**Service Bulletin (Rev. 2)****E014-2LV-0032**

<b>Model</b>	<b>FS-4300DN, FS-4200DN, FS-4100DN, FS-2100DN</b>
<b>Subject</b>	<b>Measure to prevent the drive clutch coupling failure (Light density, blank paper output or no paper feed jam (JAM0501) Measure for registration sensor 2 no arrival JAM (JAM0501/400x) and duplex sensor 2 non- arrival JAM (JAM440x))</b>

>> Rev.: Addition/correction to the content as the paper feed/conveying clutch in the paper feed drive unit registered as service parts. (6 corrections/additions on Page 1 and 2, 1 addition on Page 16, 17)  
Correction of error indication of [Drive clutch] for [Conveying clutch]. (2 locations on Page 2 and 3)

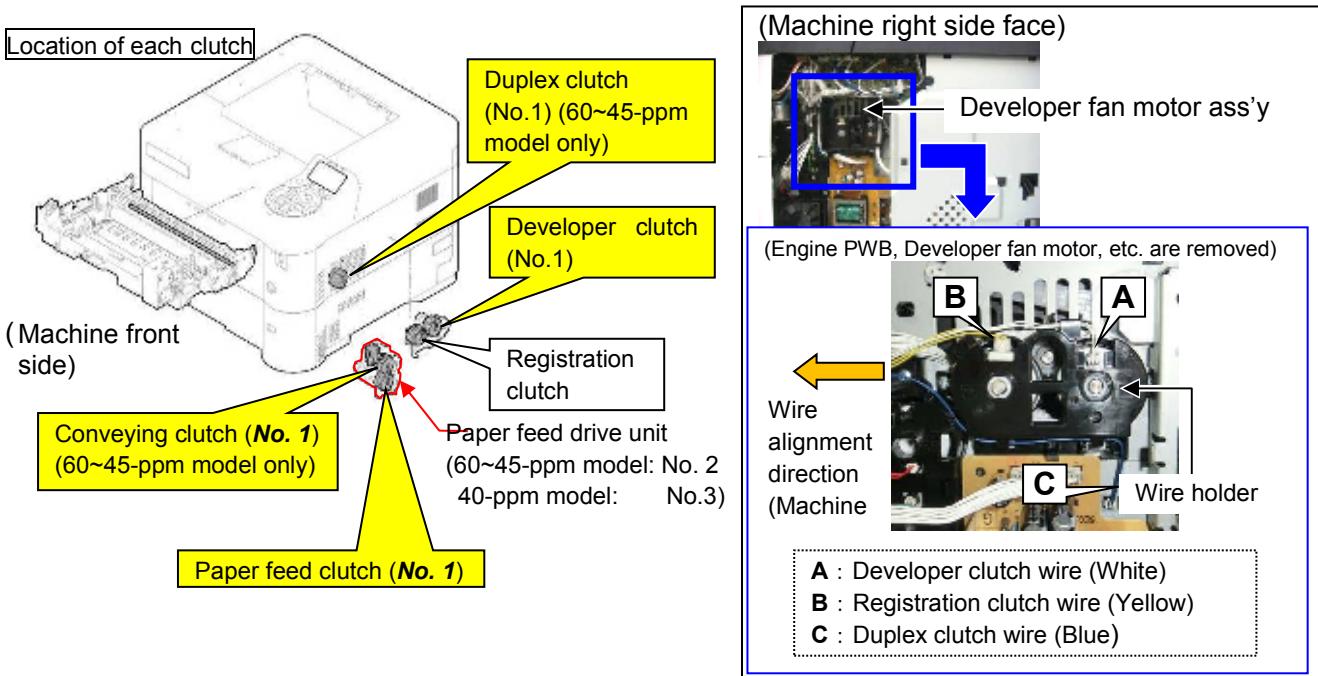
In order to assist the easier and proper wire alignment, a new banding band is added to the developer clutch wire (**A** below) and hooked to the rib of the wire holder.

The banding band is also added to the wire **B** and **C** for the registration clutch and duplex clutch (60~45-ppm model) that are aligned with a pull toward the machine front direction. (See Fig. 5 and 6 on Page 5.)

**Identifying the old/new parts****[Identification of the old/new developer/paper feed/conveying/duplex clutch]**

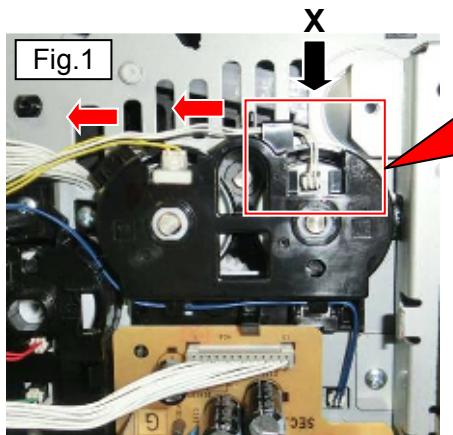
The color of the rating plate label applied on the field core of the clutch is changed from White to Yellow after changing the internal structure of the clutch.

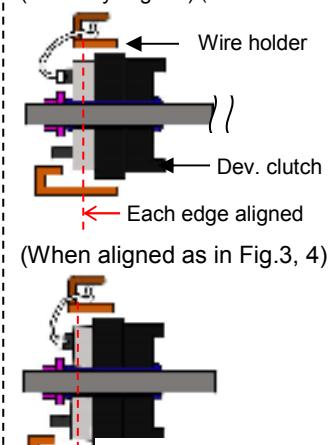
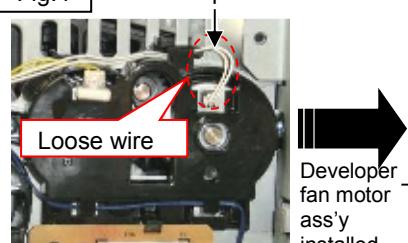
Please take extra care not to pull each clutch wire excessively in the red arrow directions as in Fig. 1 (machine front side). Also do not loosen the clutch wire at the developer clutch side at the same time to prevent wire pinching at the drive duct.

#### Fig.4 Developer clutch wire

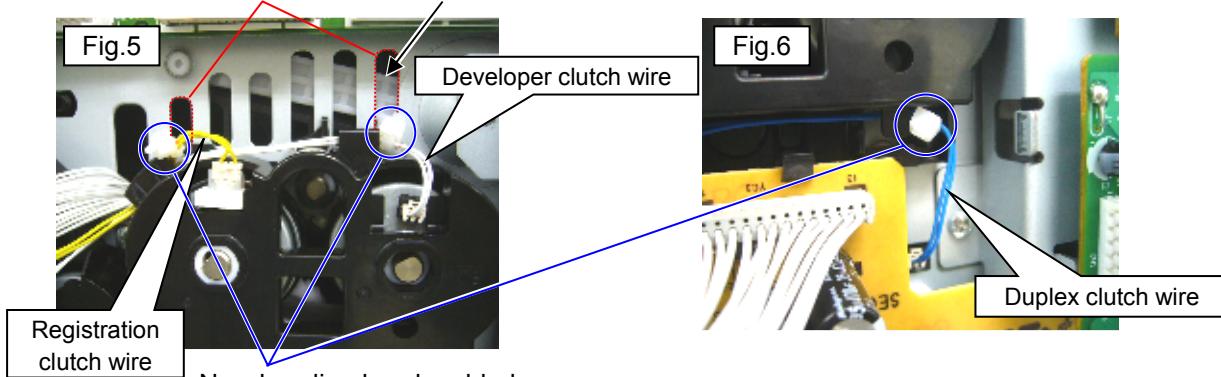
(When aligned as in Fig.3, 4)  
Edge of wire holder  
The edge of the upper part of developer clutch may become tilted toward the inside of machine.

**(Note when wiring in the new-type machine (with the added banding bands))**

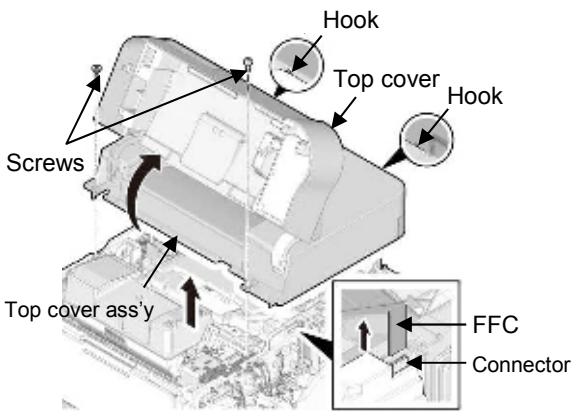
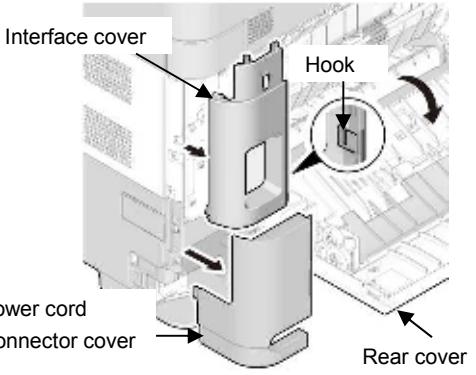
Excessive pulling of wire is prevented by aligning the wire to the machine front side after hooking the banding band to the rib at the wire holder.

Take caution so the banding part of the banding band added to the registration clutch and developer clutch wires would not enter into the louver window.

Should it occur causing the banding part to lift the right developing rail, you may not be able to remove the developer unit.
